<b>Docket Number:</b>	15-AFC-01
<b>Project Title:</b>	Puente Power Project
<b>TN #:</b>	213674
<b>Document Title:</b>	County of Ventura, Department of Airports Comments: P3 Incompatible with Oxnard Airport
<b>Description:</b>	N/A
<b>Filer:</b>	System
<b>Organization:</b>	County of Ventura, Department of Airports/Todd McNamee
<b>Submitter Role:</b>	Public Agency
<b>Submission Date:</b>	9/15/2016 2:31:27 PM
<b>Docketed Date:</b>	9/15/2016

**P3 Incompatible with Oxnard Airport**

**RE: Comments on California Energy Commission (CEC) Preliminary Staff Assessment (PSA) for Puente Power Project (P3) Dated June 20, 2016**

**TRAFFIC AND TRANSPORTATION - FIGURE 4**  
Puente Power Project - Aircraft Flight Altitudes ( October 1 - November 22, 2015)

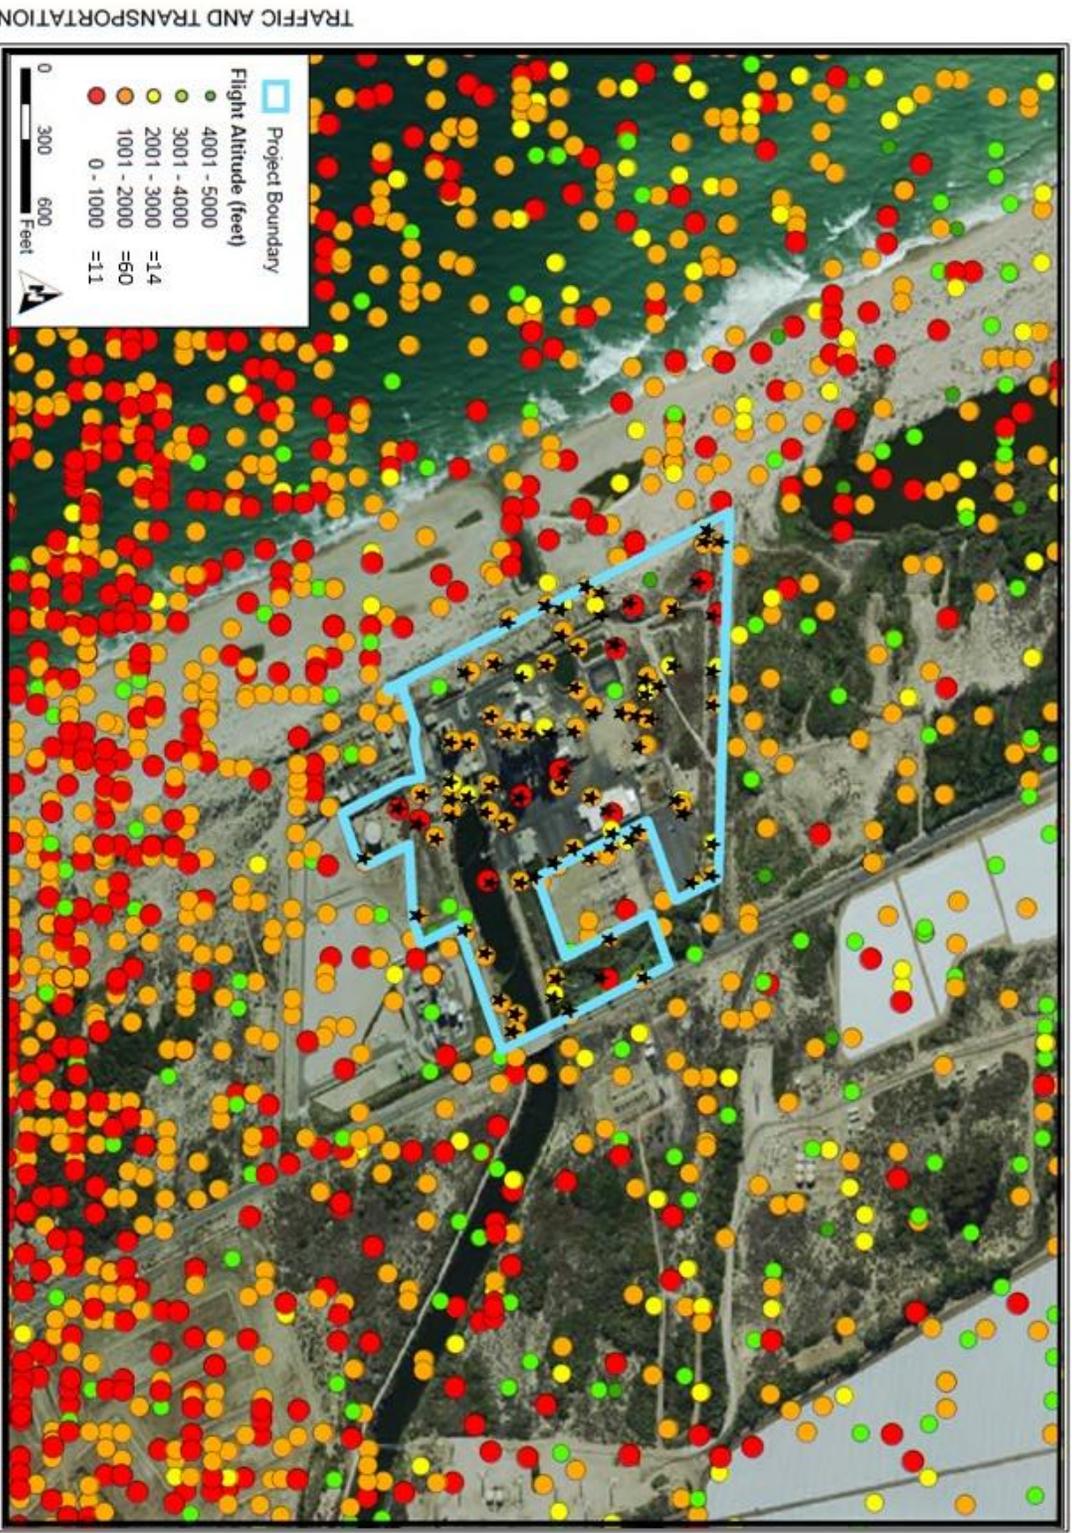
Lastly, **TRANS-7**, while possible to implement, will not likely result in all overflight being avoided all together. The DOA currently provides recommended patterns to avoid overflight of the existing power plant in a published Pilot Guide, yet Figure 4 in the Traffic and Transportation section clearly depicts overflight of the site currently occurring. Further, if it did result in overflight being avoided, it results in restricting access to the Oxnard Airport in a manner that does not currently exist. This is of concern for the existing aircraft utilizing Oxnard Airport, and could negatively impact the DOA's efforts to restore commercial airline service to Oxnard Airport.

Typical Departure  
could result in aircraft  
overflight of P3 at altitudes  
much less than 4,260 feet.

### Light GA - Probability of Severe Turbulence

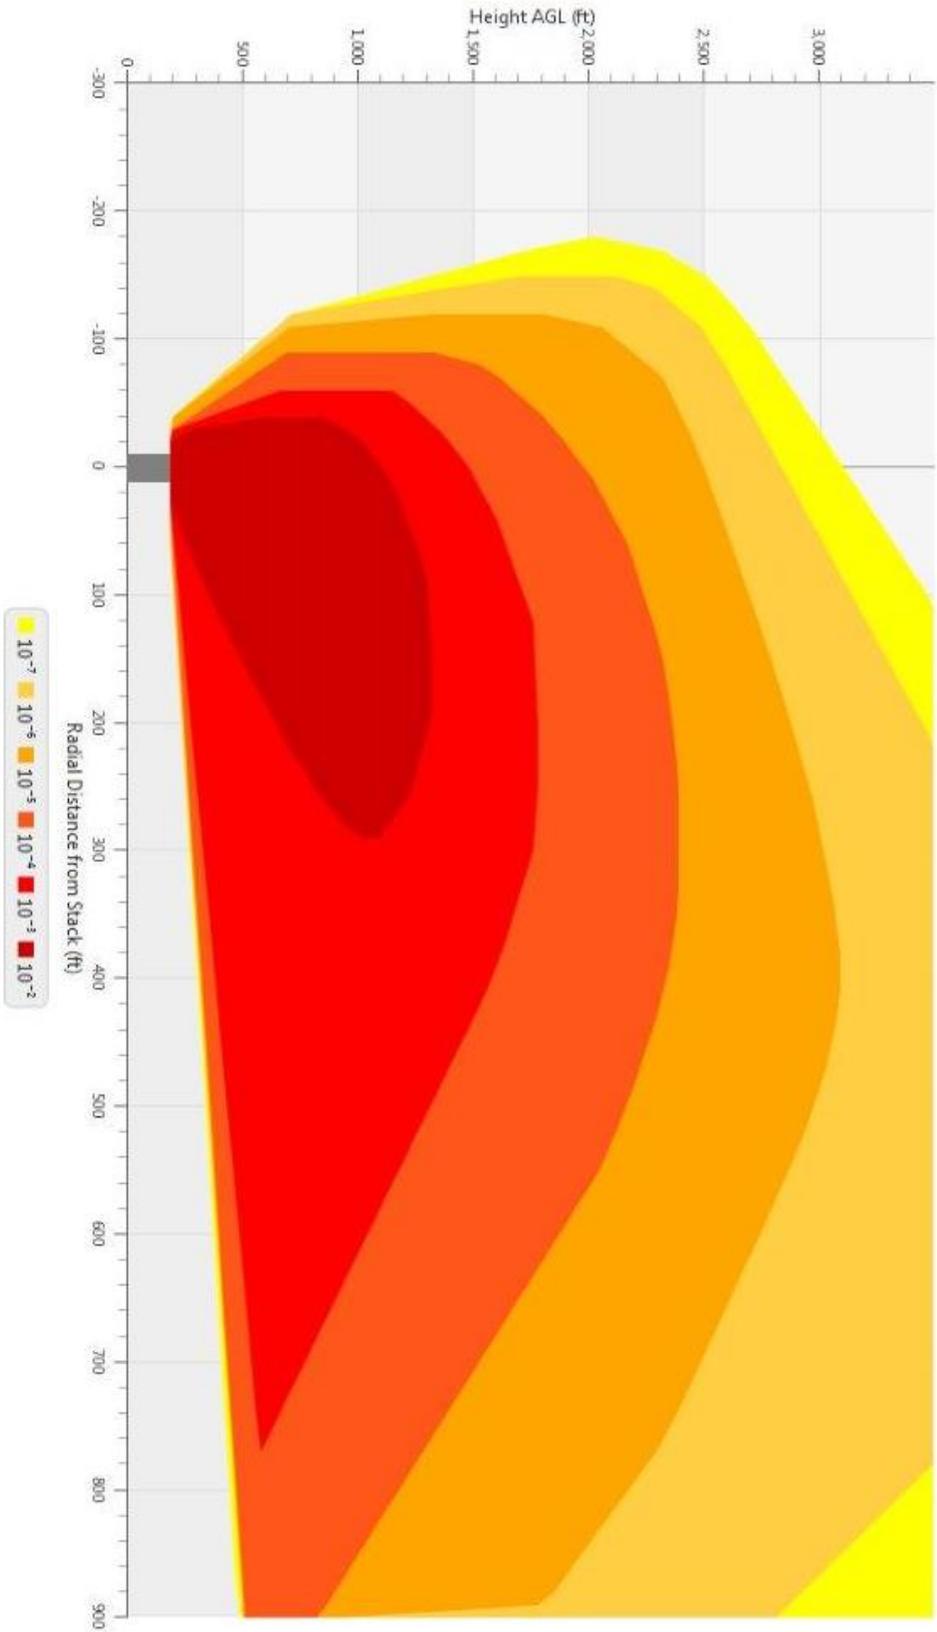
The MITRE model results provided by CEC staff via email on September 14, shows severe turbulence will likely be encountered by light general aviation (GA) aircraft at altitudes exceeding 3,000 feet, but with higher probability at lower altitudes. The DOA requests that a more thorough analysis of the plume be conducted, incorporating the MITRE model, prior to approval of the project.
